## **Remarks – General**

### **1. Request for Approval of Proposed Drawings, Correcting Typographic Errors**

**Proposed Drawwings**

**Fig. 9**

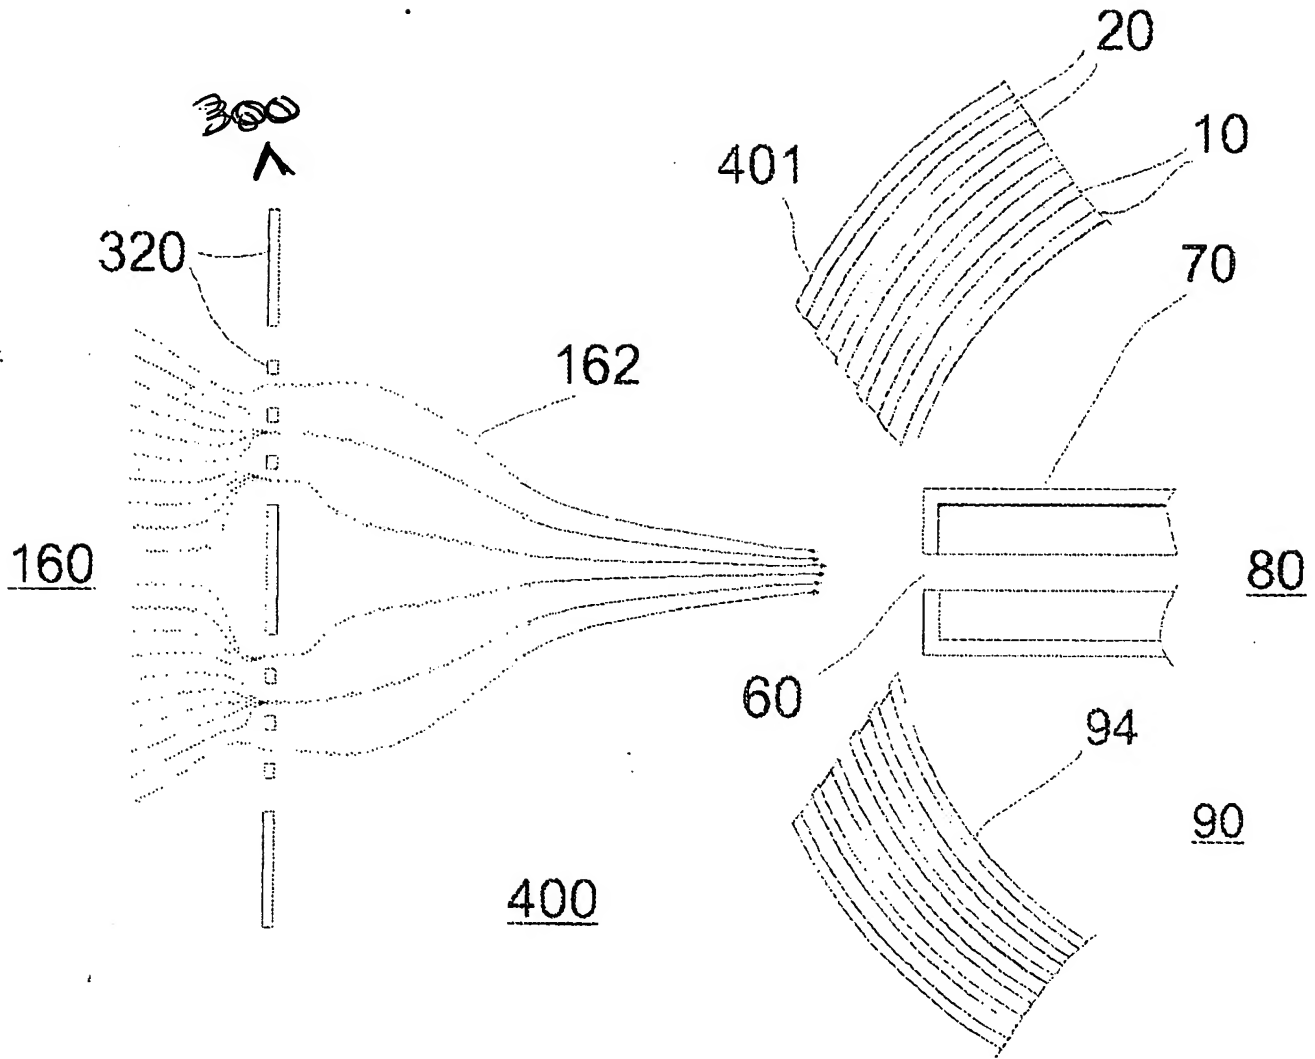
Applicants respectfully request permission to amend the Figs 9 and 10 of record of the above application. The proposed changes are indicated in red on the photocopy of Figs 9 and 10 (see Appendix A) along with new drawings.

Fig 9 shows a cross-sectional view of a lens composed of a hemispheric-shaped array of metal laminates adjacent to a planar-shaped high-transmission element **300** comprised of a single electrode **320** and an insulating base **330** partially removed; showing ion trajectories **162**.

Applicants respectfully request permission to amend the drawings, Fig 9 and 10, of this application (10/661,842). The proposed changes are indicated in red on the photocopies of Figs 9 and 10 thereof attached. New drawings are also attached.

**Fig. 10**

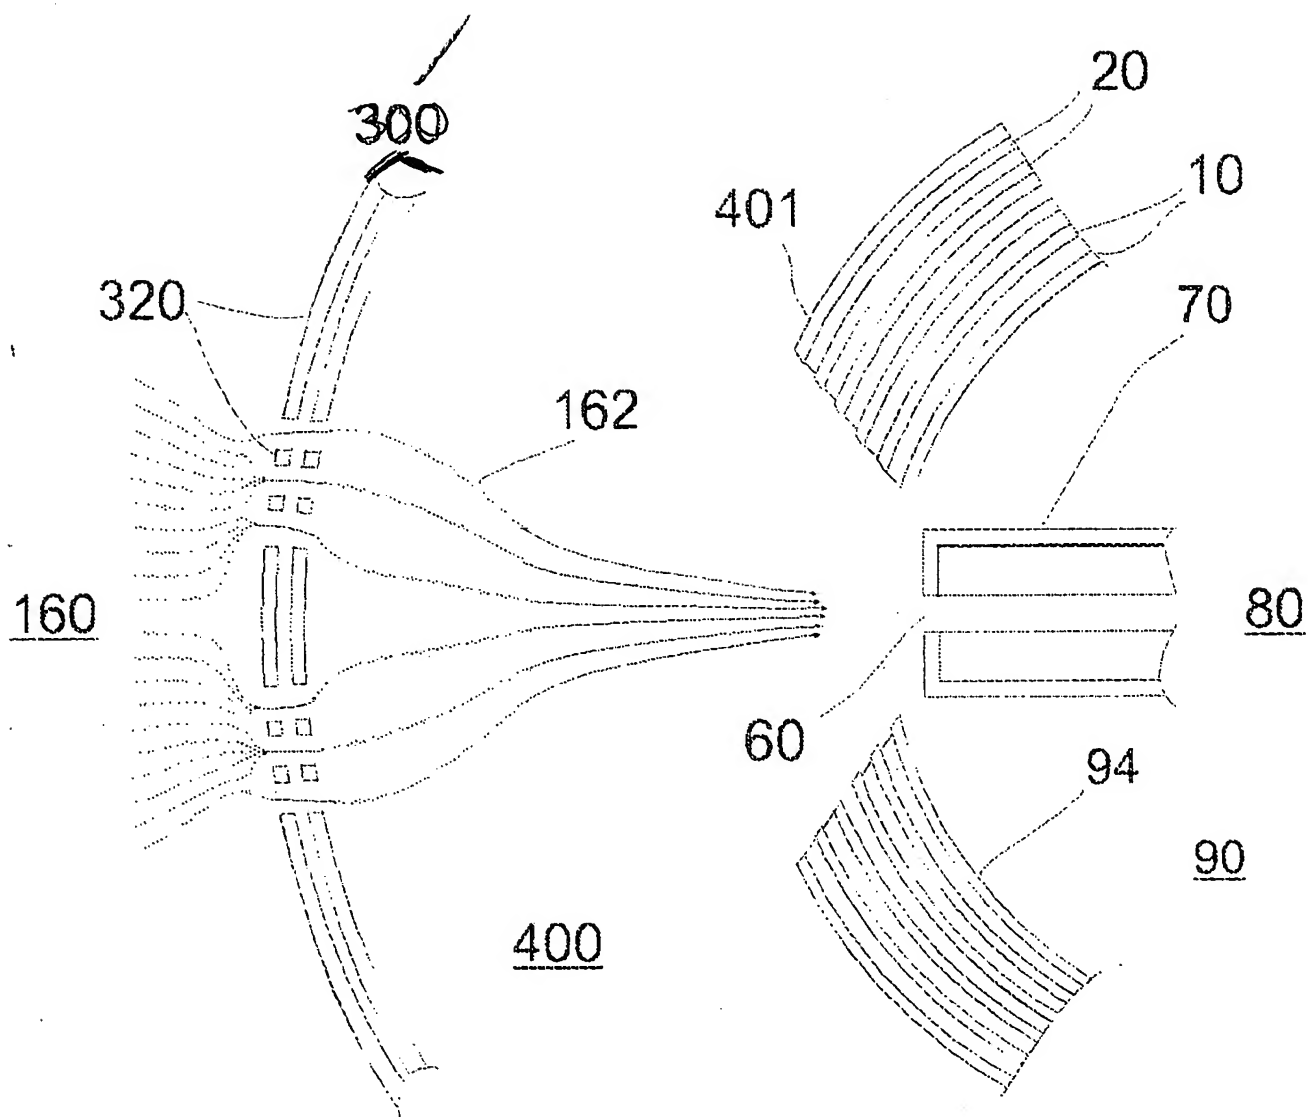
Fig 10 shows a cross-sectional view of a similar lens adjacent to a hemispherical-shaped laminated high transmission element (Lam-HTE) **300**.
